From:	Justin Simons <justins@georgetown.tas.gov.au></justins@georgetown.tas.gov.au>
Sent:	Thursday, 1 June 2023 12:28 PM
То:	TPC Enquiry; Barlund, Paola
Cc:	James Stewart; Andrew McCarthy; McCrossen, Samuel
Subject:	George Town Draft LPS - Directions - Planning Authority 2
Attachments:	QA - Flood-prone Hazard Areas Code - May23 (Depth_0.1m).pdf; 20230601 George Town Flood-Prone Area Rationalisation Memo.pdf

Flood-Prone Hazard Areas Code - Proposed changes (D>0.1m, D.V>0.02m2/s, A>100m2)

Re: FLOOD PRONE HAZARD AREAS OVERLAY AMEMENDMENT FILTERING

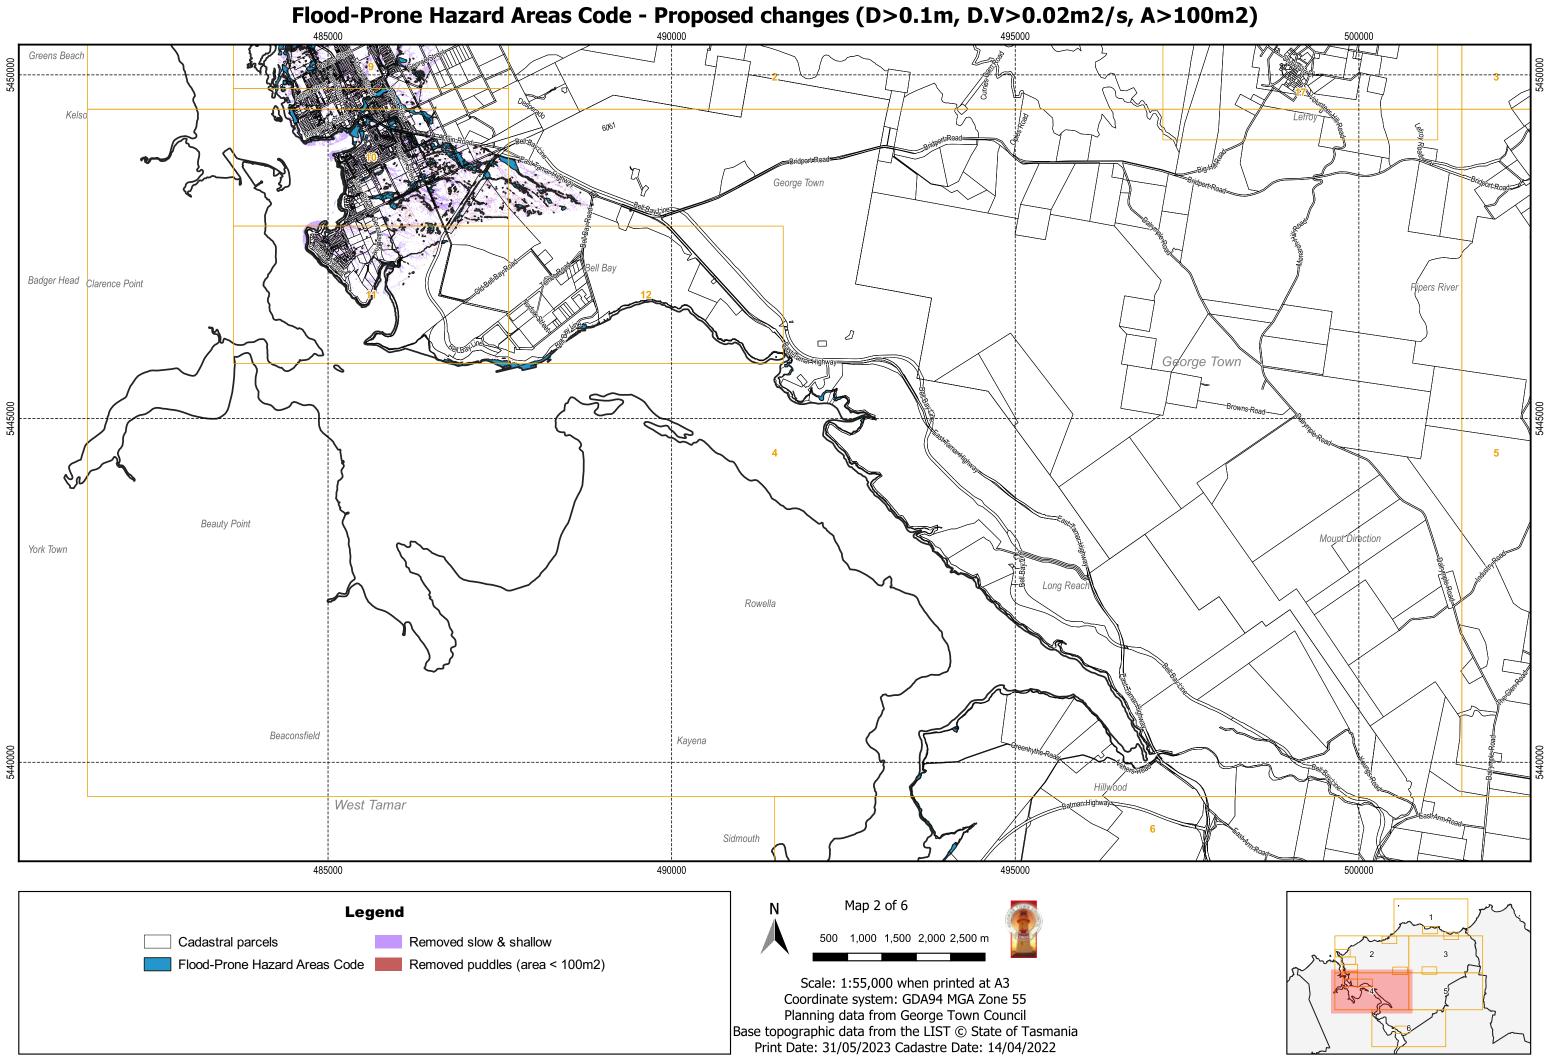
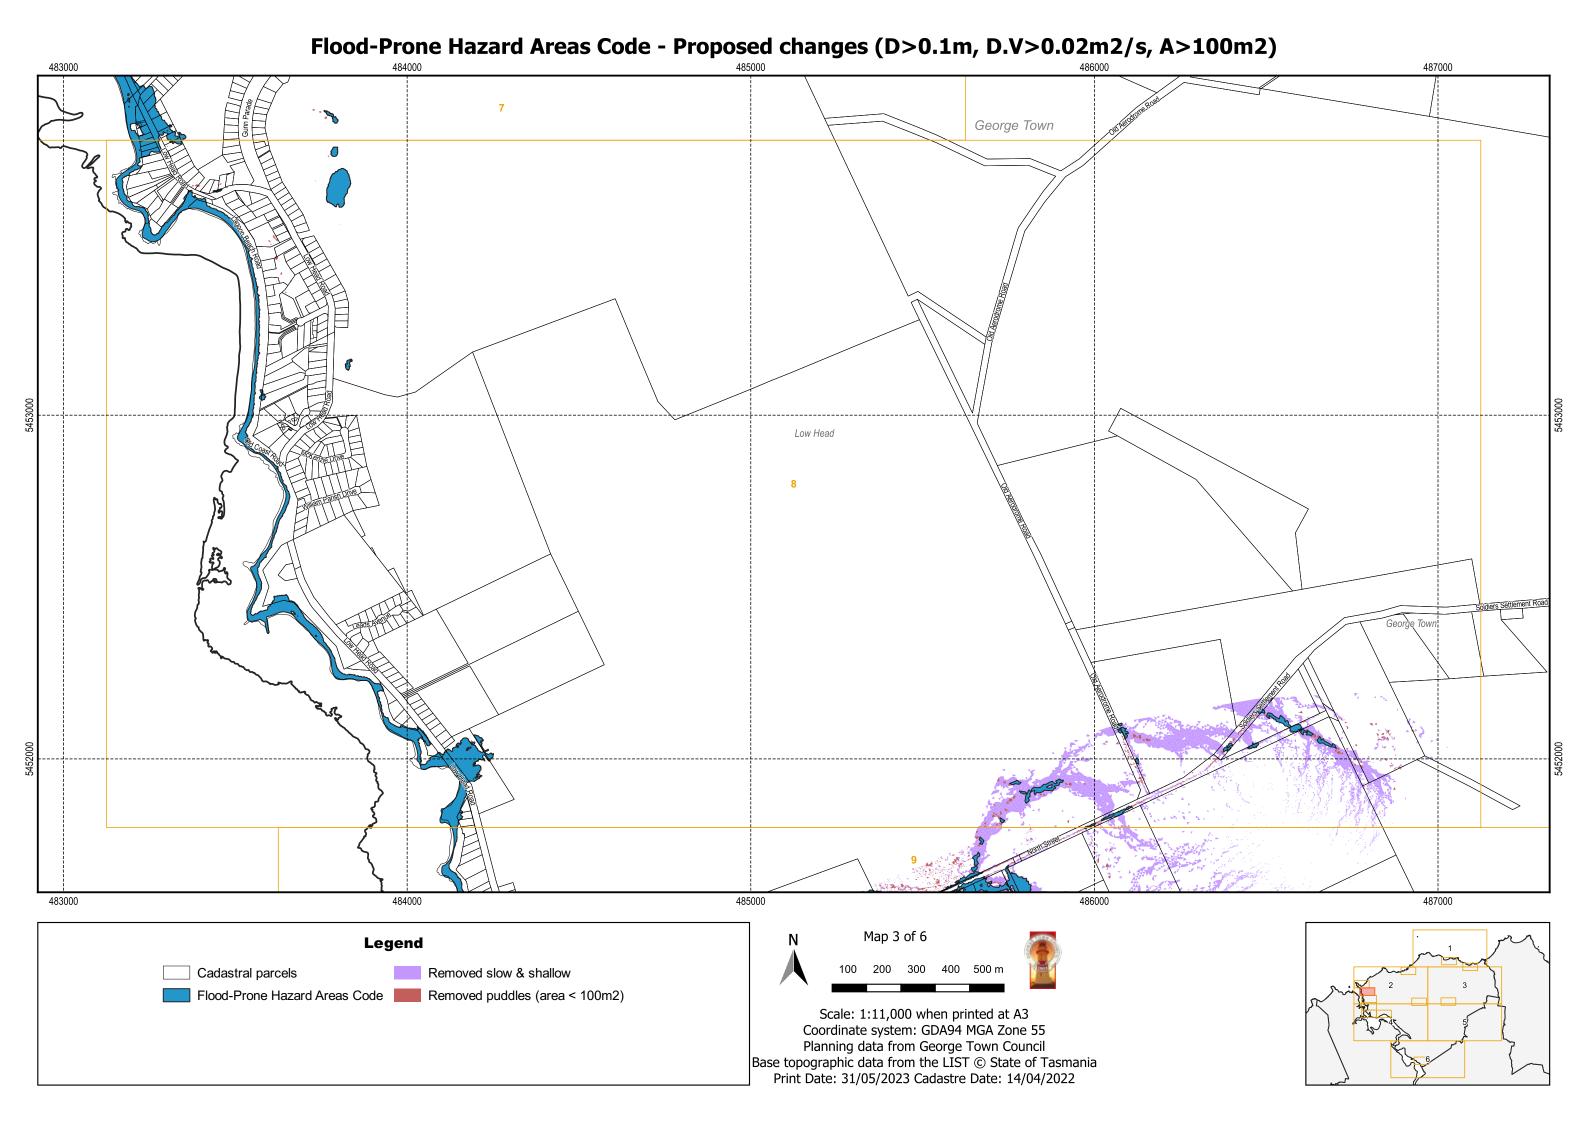
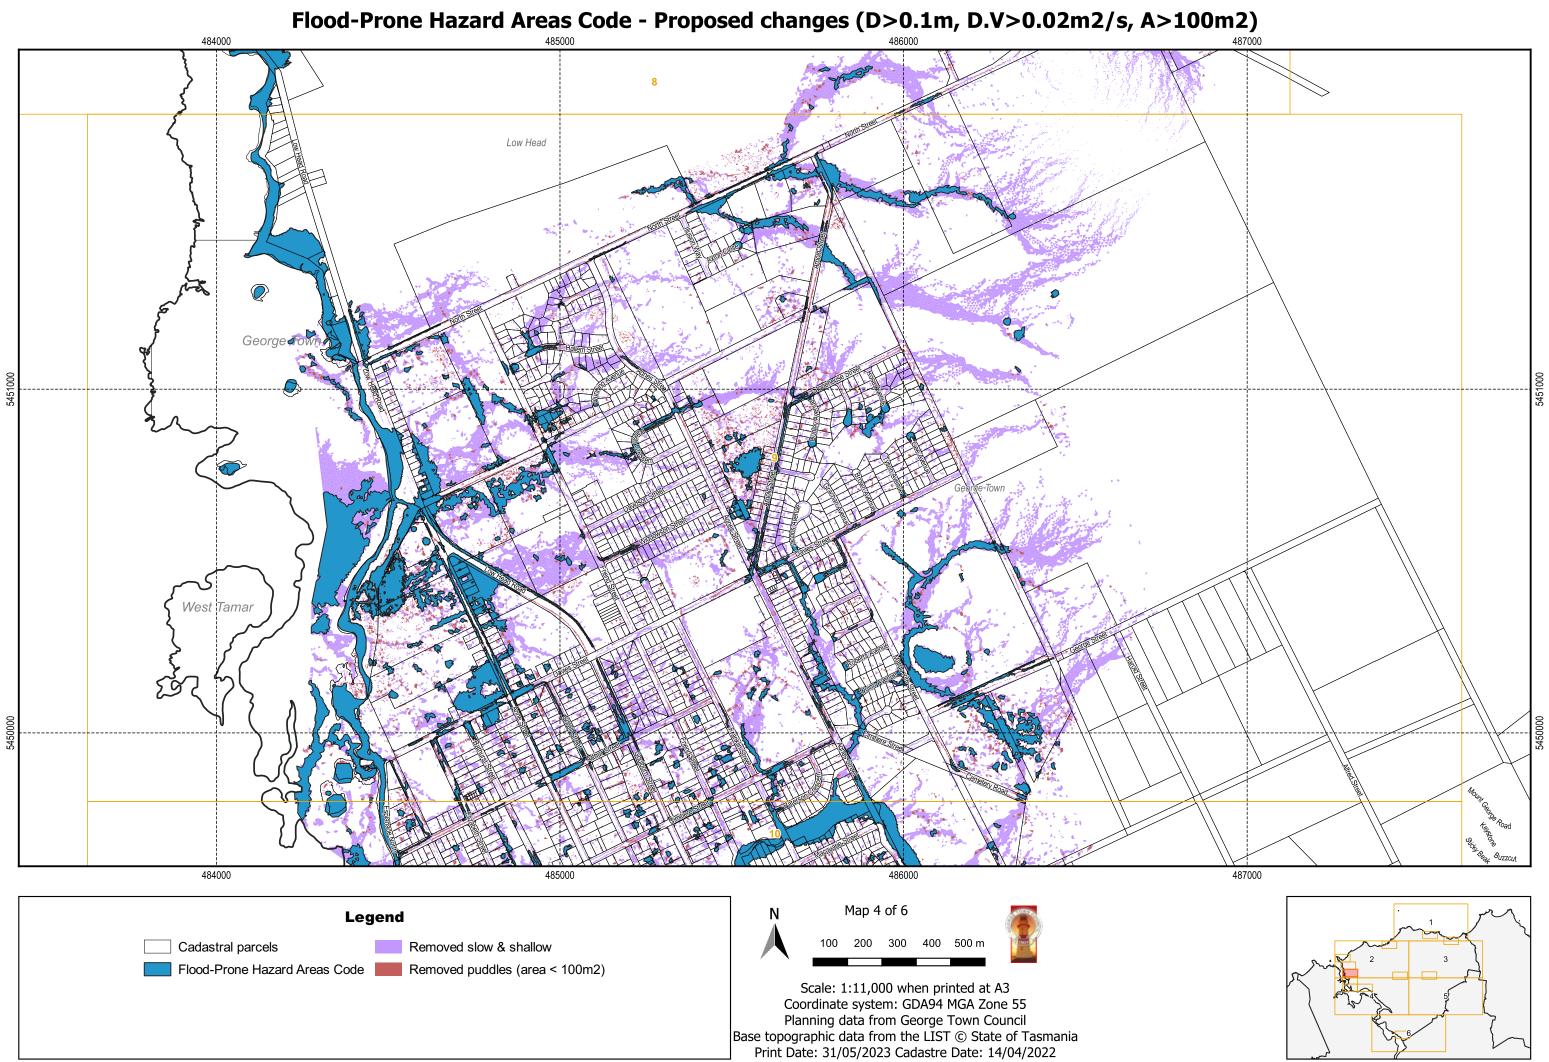
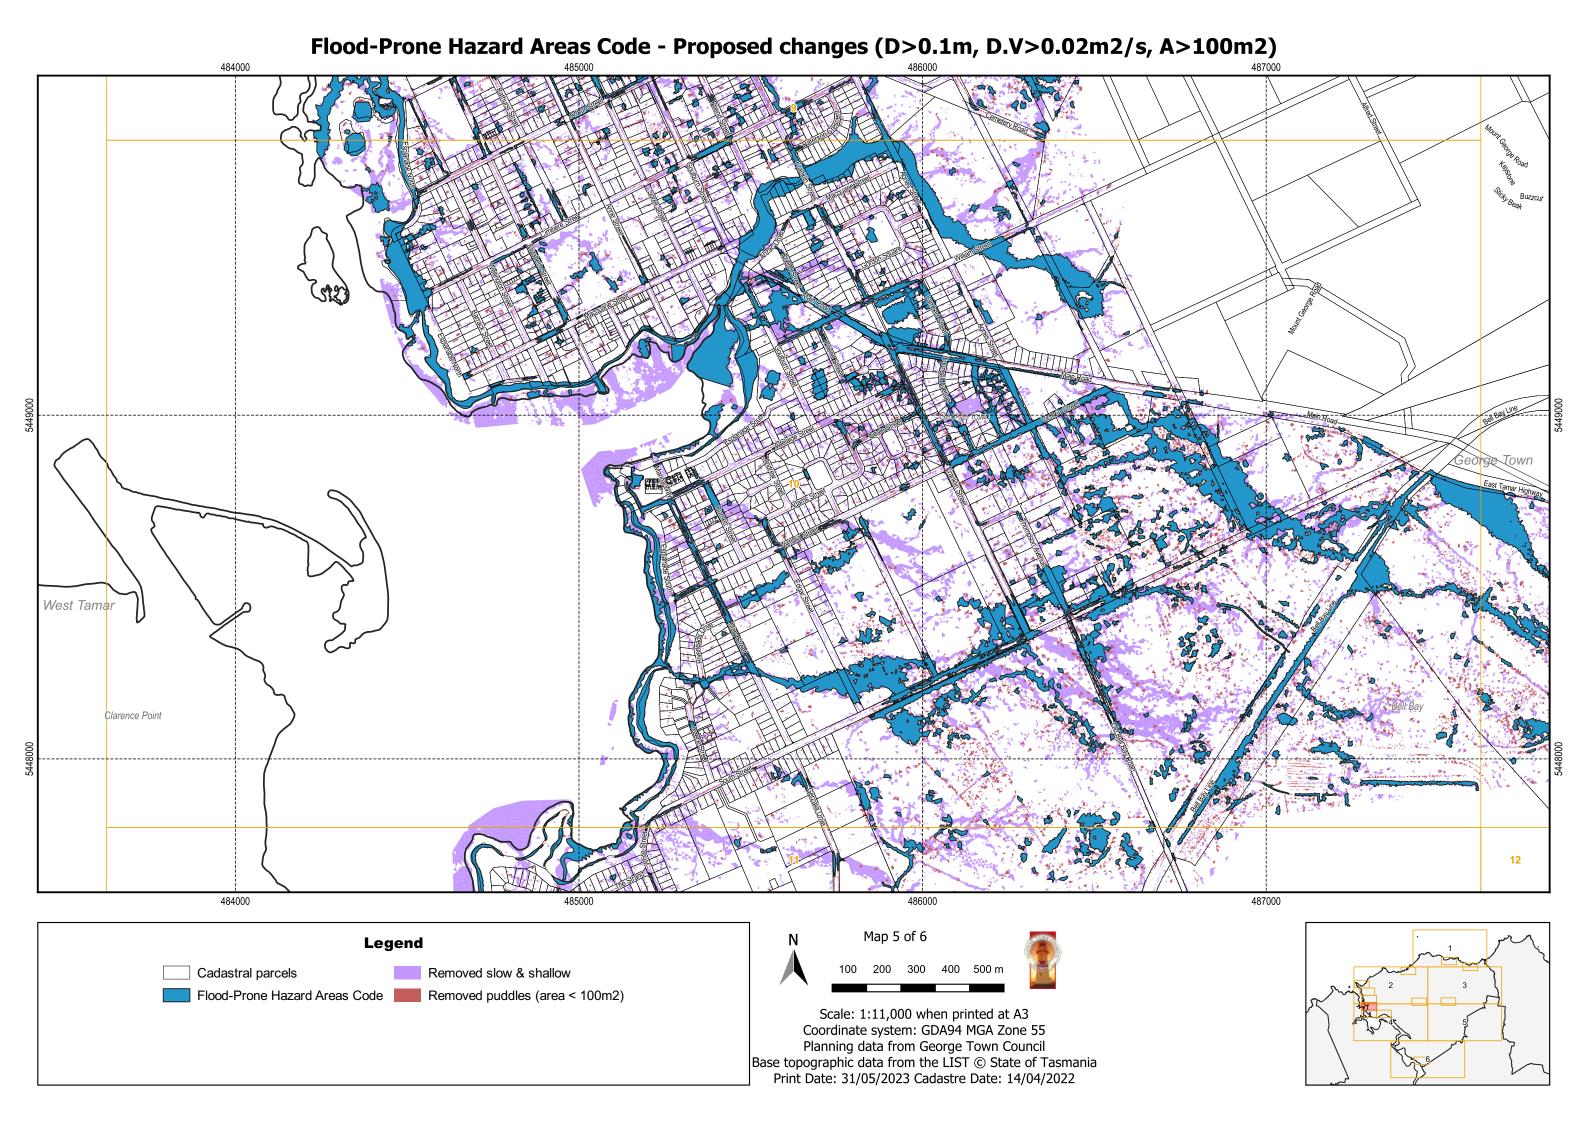
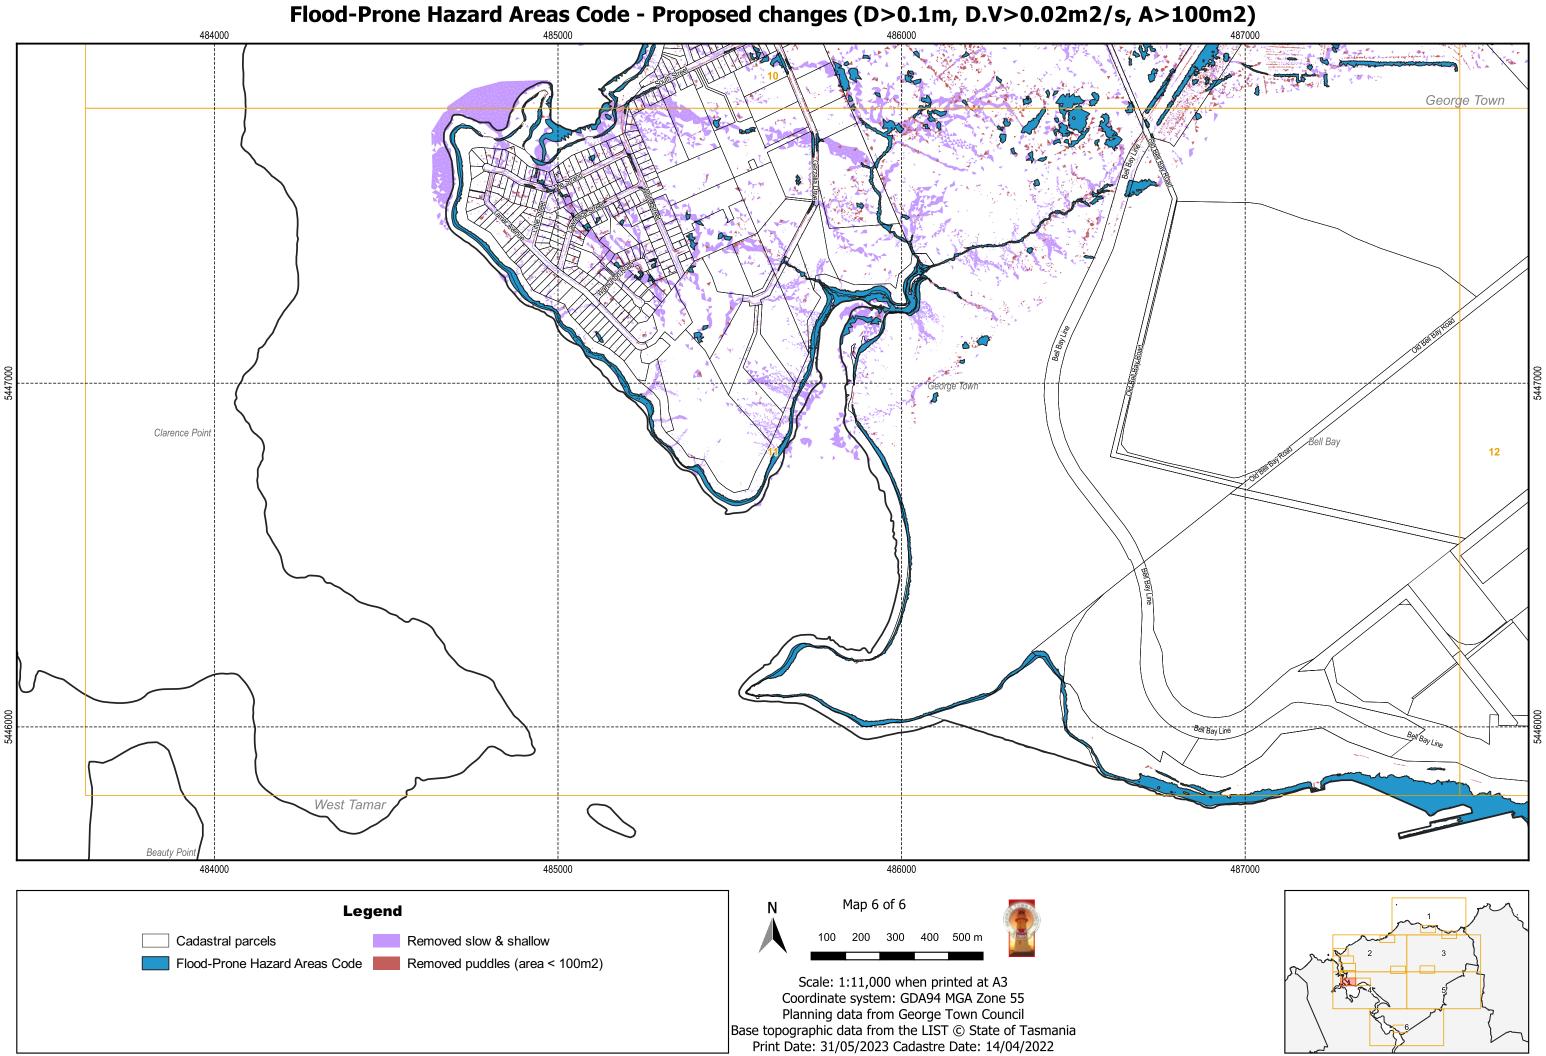
After reviewing the original flood mapping, and GTCs proposed thresholds, Hydrodynamica and GTC propose a Flood-Prone Hazard Area based on the following revised thresholds:

- Depth > 0.1m (100mm); or
- Depth x velocity product >0.02m²/s; and
- Ponding >100 m² in total area

It is our opinion that the proposed levels are appropriate, as the depths removed are extremely unlikely to have removed any flooding which would enter a dwelling. The removed flooding is marginal outdoor flooding which holds little to no risk to people or property. Flooding of less than 100mm depth would require a velocity of 2 m/s in order to raise the risk to a H2 HVC level, at which point it becomes unsafe for small vehicles. Although York Creek runs through the urban area, which results from runoff from the elevated Mount George and George Town Sugarloaf, the George Town urban area itself relatively flat and not subject to significant velocities.
